New Reactors Division – Generic Design Assessment
Step 4 Assessment of Internal Hazards for the UK HPR1000 Reactor

Assessment Report ONR-NR-AR-21-012
Revision 0
January 2022

Figure 2: Position of Identified barriers in relation to BRA2631ZRM

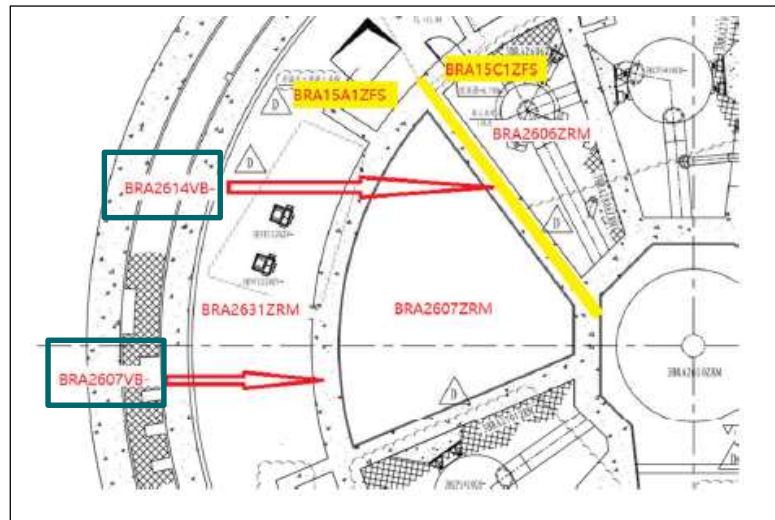
190. It can be seen in figure 2 that room BRA2631ZRM which is located at level +6.5m of the BRX is adjacent to barrier BRA2607VB. The bounding scenario IH-IF-BRX-02 is concerned with the impact to barrier BRA2614VB (highlighted in yellow) as this forms a divisional boundary.

191. Figure 2 also shows that there is spatial separation between room BRA2631ZRM and BRA2614VB; additionally, the wall BRA2607VB provides shielding from localised heat

effects. In the analysis, the RP assumed that the target barrier BRA2614VB is in the location of BRA2607VB, which the RP deemed a 'Virtual Wall'. No account has been taken in the analysis for the additional wall BRA2607VB.

192. I note that the SSCs and combustibles in proximity to this room (and for which fire spread may be possible) belong to the same division, therefore, I accept that despite any fire spread within this area, the other two redundant trains should remain unaffected. The RP confirmed (Ref. 57) that there are no HIC in this room or in the other two connecting rooms BRA2632ZRM and BRA2633ZRM located at either side of BRA2631ZRM. Virtual boundaries connect these three rooms and the distance between combustibles in different divisions is stated to be more than 6m for BRA2631ZRM at the closest point (Ref. 57).

Figure 3: Illustration of the blast loads on the barriers surrounding the accumulators.

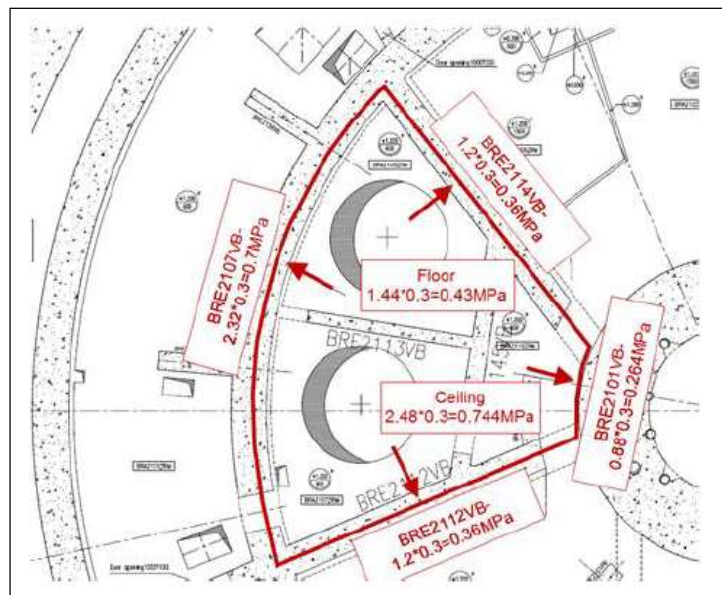
- Based on the updated loads, the claimed barrier BRE2113VB design cannot be substantiated against the failure of the accumulator.
- The RP provided clarification of the positioning of the isolation and check valves to prevent loss of system integrity. These valves are located within the annular space behind the secondary shielding wall.

- The RP also re-evaluated all the key barriers surrounding the two accumulators following a domino failure. The RP provided a summary of the loadings expected and applied them to static equivalent loads in line with ACI349M and assessed the barrier withstand. In all instances the RP applied a dynamic loading factor of 0.3. In all instances, except for the barrier BRE2113VB, the RP claimed they would withstand. The affected barriers are illustrated in figure 3 below:

Figure 4: Illustration of barriers claimed for the exception to segregation areas.

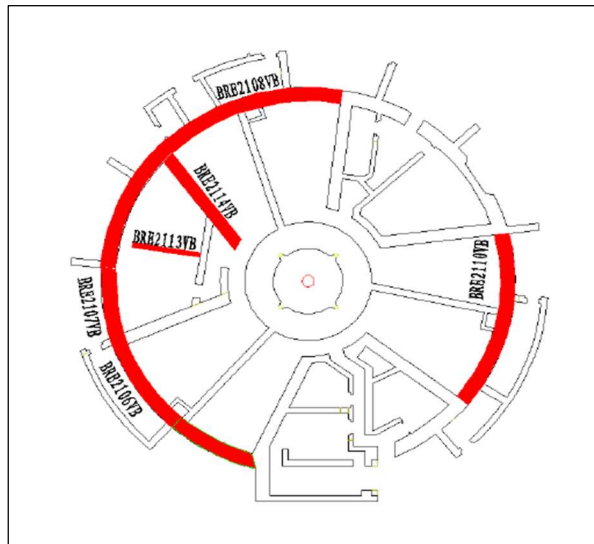
- IH-IE-BRX-05 – This scenario relates to the failure of the surge-line, impacting several pressure sensors for the pressuriser.
 - IH-IE-BRX-06 – This scenario relates to the failure of accumulator located in BRA2107ZRM and high-pressure pipes BRX2101ZRM, impacting the narrow range pressure sensors for the steam generators.

395. In all the scenarios listed above the principal safety measures claimed by the RP for protection of the sensors and pipes is the secondary shielding wall. The RP had derived the blast loads from its analysis and used them for barrier substantiation (Ref. 83). The barriers claimed for these scenarios are illustrated in figure 4 below:

396. In all instances of the barrier substantiation the RP had applied the equivalent static method (ACI349-M) (Ref. 40) to determine the global resistance of the identified barriers. The RP claimed that all the required barriers meet their safety functional requirements for strength, and therefore all scenarios have adequate protection in place and in my view satisfies SAPs EHA.3 and EHA.6. However, as highlighted in the previous section, the RP had not adequately considered reflective overpressures in the derivation of the blast loadings for barrier substantiation assessment. This is a shortfall against SAP EHA.2 and I raised it through RQ-UKHPR1000-1766 (Ref. 126)

Figure 5: Illustration of Steam line configuration

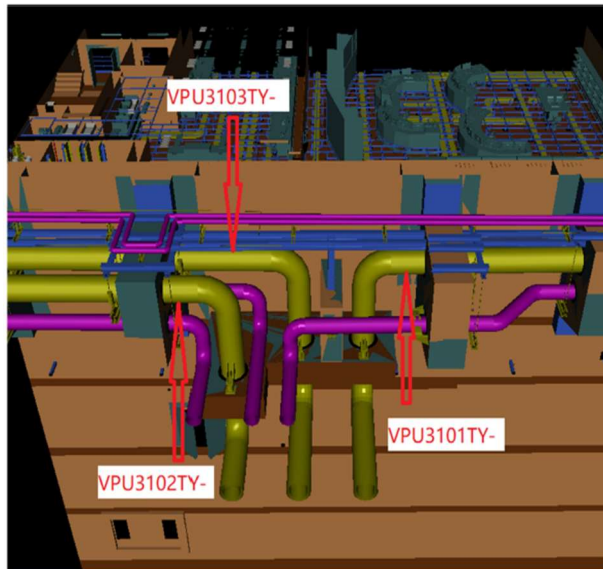
443. The RP's responses to RQ-UKHPR1000-0925 (Ref. 141) and RQ-UKHPR1000-1340 (Ref. 137) highlighted the following:

- The failure of the main steam line pipe VPU3101TY would result in an overpressure of 82kPa.
- The failure of all three high pressure pipes would result in overpressure of 310kPa.
- The dynamic loading factor of 0.2 has been derived in accordance with ACI349M-13 (Ref. 40).
- The MCR external wall is designed to withstand aircraft impact and the external wall of the MCR has been increased to 1.6m.
- There are multiple pipe restraints on the external wall to limit the pipe whip and avoid loads on the wall.

444. I have assessed the responses from the RP as described above in addition to the explosion report (Ref. 117) and I note the following:
- The explosion analysis undertaken by the RP related only to the failure of the VPU pipes. This is because the RP had screened out BLEVE of the ARE pipe due to its operating temperature the comments I made above in this regard are also relevant here. However, given that the main steam line operates at temperatures meeting the RP's BLEVE criteria and is larger in diameter, I am satisfied that the blast loads in this scenario will be dominated by the main steam line failure considered to be the bounding scenario, satisfying SAP EHA.3.

Figure 6: PTR [FPCTS] Trains C and A in the BFX

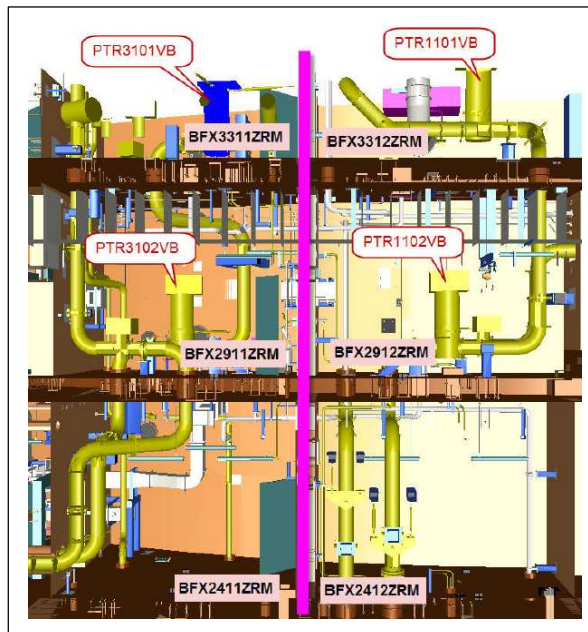
555. The Division C and Division A rooms are arranged above each other in vertical 'slices' with pipework and isolation valves in the lower rooms at the levels +9.10m and +13.70m. The Division C rooms do not have any floor openings, in order to prevent floodwater flooding up from below. The flood relief path for a flooding in Division C room BFX2911ZRM is presented in the safety case and relies on floodwater flowing transversely to Division A (room 2912) then vertically through Division A (room 2412)

and then transversely spreading through Division C (room 2411) and Division A (room 2406). This arrangement is illustrated below in figure 6.

556. The equipment in Division A is claimed not to fail as flood heights in room BFX2912ZRM are not considered by the RP as reaching a level high enough to cause damage. The analysis by the RP (Ref. 149), shows that the flood height margin to the valves is negligible (0.07 m).

Figure 7: Trajectory of pipe whip in BFX1044ZRM

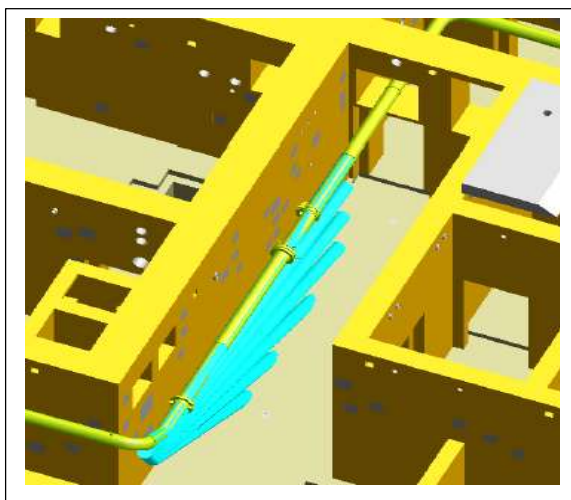
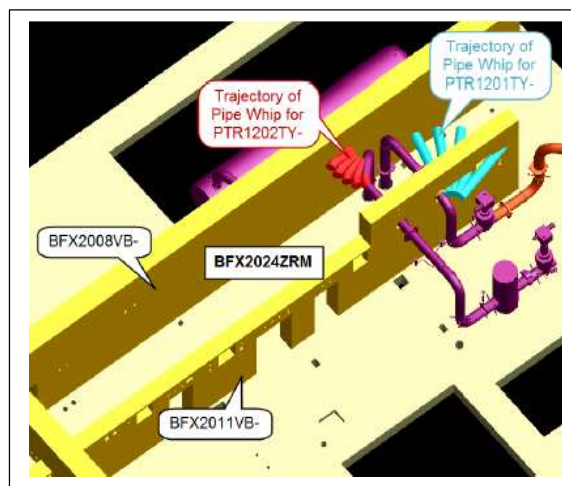
against the bounding case values derived in the BFX HEPF report (Ref. 136) for pipe whip (1353 kJ). This is considered the most challenging hazard load following a HEPF. Through this analysis the RP identified two rooms (BFX1044ZRM and BFX2024ZRM, figures 7 and 8) where the pipe whip energy was greater than the current bounding value contained in the BFX HEPF report (Ref. 136).

891. The RP's analysis concluded that for both rooms the pipe whip value was 3648.59 kJ, which is significantly greater than the values derived in the bounding cases against divisional barriers described above. The RP then applied this loading to the civil structure analysis which provided confidence that the most challenging loads in the building have been used.

892. Through my assessment of the RP's response to RO-UKHPR1000-054 (Ref. 58), I am satisfied that the RP provided sufficient evidence to address the additional hazards from HEPF that could impact non-barrier walls identified within the BFX, exceeding the current bounding cases loads for barrier walls defined in the HEPF report (Ref. 136). The full analysis of these loads on these non-barrier elements was out of the scope for GDA. However, the response to RO-UKHPR1000-054 (Ref. 58) has provided assurances that the preliminary structural substantiation results indicated that the barriers had a global withstand and therefore their safety functions would be delivered. The assessment of the effects of the loads to load bearing non-barrier civil structures

Figure 9: The elevation of VVP [MSS] / ARE [MFFCS]

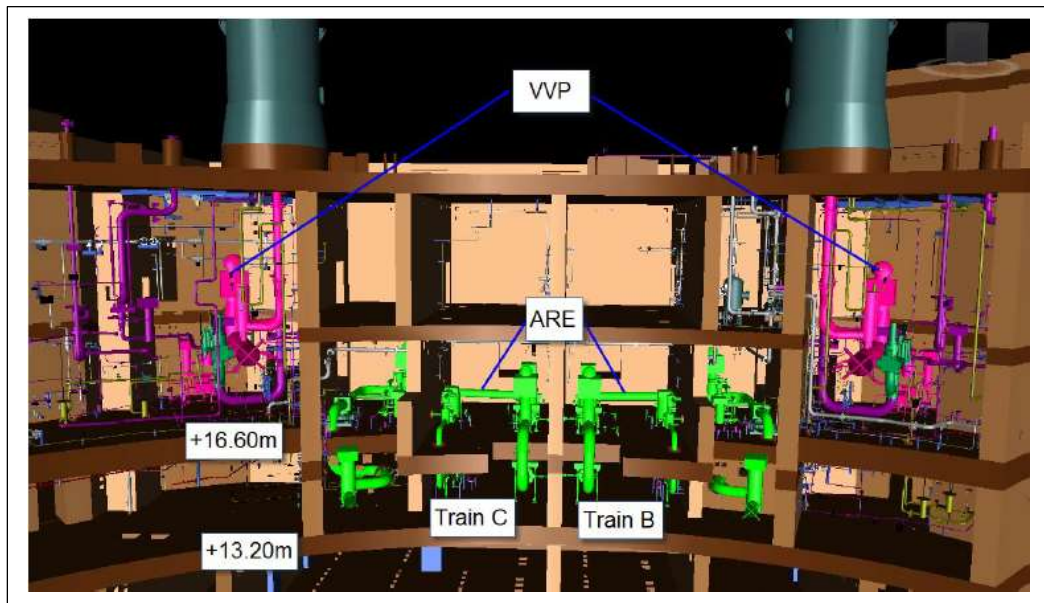
914. For the area identified by the RP in the BSB, at level +13.20m to +20.80m both train B and train C of the Main Steam System (VVP [MSS]) and Main Feedwater Flow Control System (ARE [MFFCS]) are located. This area mainly contains redundant trains of main feedwater lines, main feedwater isolation valves, and main steam isolation valves. A general arrangement is illustrated below in figure 9:

915. For this location the RP identified the following bounding cases that impact the exception to segregation criteria:
- IH-HEPF-BSX-07 – Train B ARE Impacting Redundant Train C of ARE in BSB3628ZRM. The two trains are separated by a partial wall BSB3619VB.
 - IH-HEPF-BSX-08 – Failure of ARE2510TY may impact redundant safety sensors in BSB3329ZRM by flooding.

Figure 10: ARE [MFFCS] Train A and B exception to segregation area.

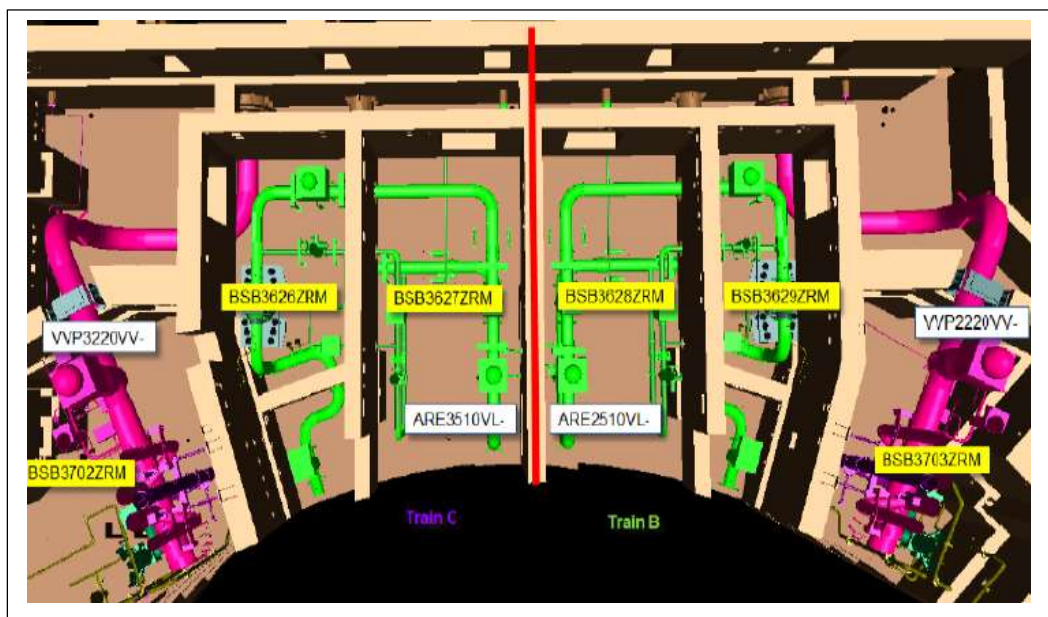
917. From my assessment of IH-HEPF-BSX-07, I noted that in the analysis of consequences, the RP makes no claims on the divisional barrier BSB3619VB (as shown in figure 10) segregating the two feedwater trains. Therefore, the RP assumes that following a pipe break of ARE2510TY in room BSB3628ZRM, the adjacent pipe ARE3510TY in room BSB3627ZRM would also be damaged.

918. It is also recognised in the BSX HEPF report (Ref. 140) that several redundant safety sensors would also be lost. A functional analysis was undertaken by the RP (Ref. 140) to demonstrate that loss of the two ARE systems would not impact plant safety and was tolerable. The functional analysis highlighted that the ARE [MFFCS] is not an engineered safety system as it is used in normal operation. The RP highlighted that if the two trains of ARE [MFFCS] are lost, the emergency feedwater system (ASG [EFWS]) is available (which is an engineered safety system). The RP stated that the ASG [EFWS] can be actuated to remove heat and bring the unit to safe state. There are three trains of ASG [EFWS] which are physically segregated and located in BSA, BSB and BSC respectively.

919. My assessment of the RP's functional analysis had provided me with some confidence that there are segregated and diverse safety systems available if the two systems failed. However, it was my observation that the RP's analysis had not assessed the physical impact of the ARE system to the actual building and the wider potential consequences such as overpressure. I also noted that the RP had stated that that barrier was considered as defence in depth in the hazards schedule (Ref. 92), however, the actual claim on the barrier was not clear particularly as the RP had already assumed it would fail.

Figure 11: Generic UK HPR1000 GDA Building Layout

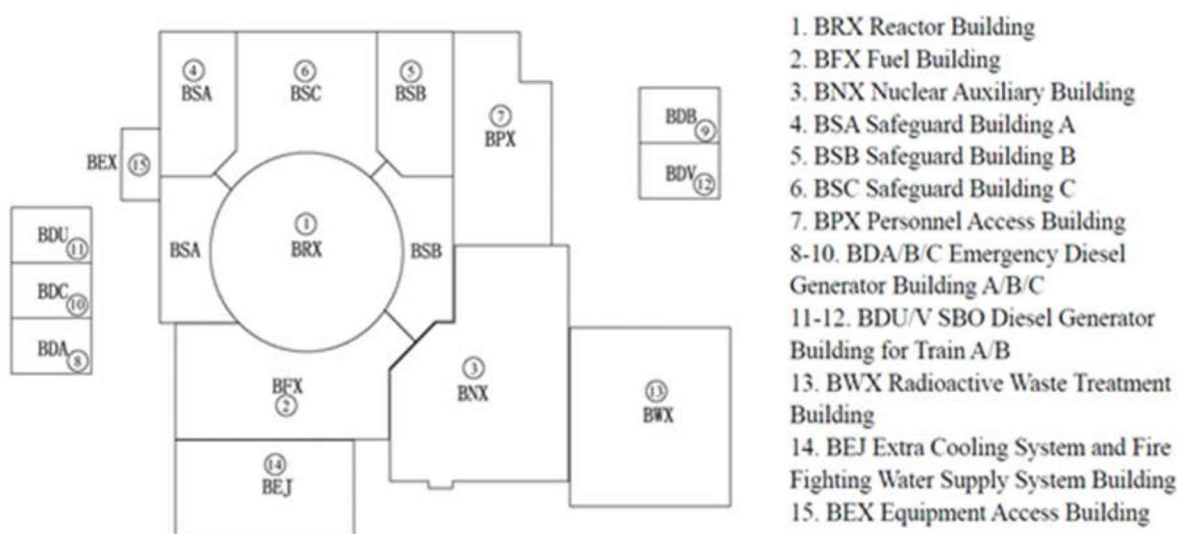
1041. I also questioned the identification of safety functional requirements of barriers between diverse safety relevant systems. In response (Ref. 246) the RP stated that the

- Three emergency diesel generators in BDA/BDB/BDC provide backup for each other.
- Since BDB is segregated with BDA and BDC by distance, a fire cannot impact the three emergency diesel generators at the same time.
- Defence-in-depth measures (such as fire detectors and fixed firefighting systems) control the fire spread (these are not claimed as safety measures).

1042. In order to clearly understand the RP's response, I reviewed the generic GDA building layout provided in the generic plant description report (Ref. 125) and presented in figure 11 above. This figure clearly shows that building BDA and BDC are located next to each other on the left-hand side of the reactor building, with BDB being located in a completely separate place, on the other side of the reactor building. I have reviewed the RP's response (Ref. 246) together with the generic building layout and in my judgement this RQ response is acceptable for GDA, however further analysis and consideration of other potential internal hazards, such as flood and turbine disintegration as well as defence in depth measures will be required during detailed design. This analysis should address the potential for EDGs to be unavailable due to maintenance or following other failures. In addition, the design and location of the EDGs is subject to the licensee's choice. I have therefore raised the following Assessment Finding, to meet the expectations of ONR SAPs ESS.2 and ELO.4, to be addressed at detailed design when the licensee is finalising the building layout and the detailed design safety case.
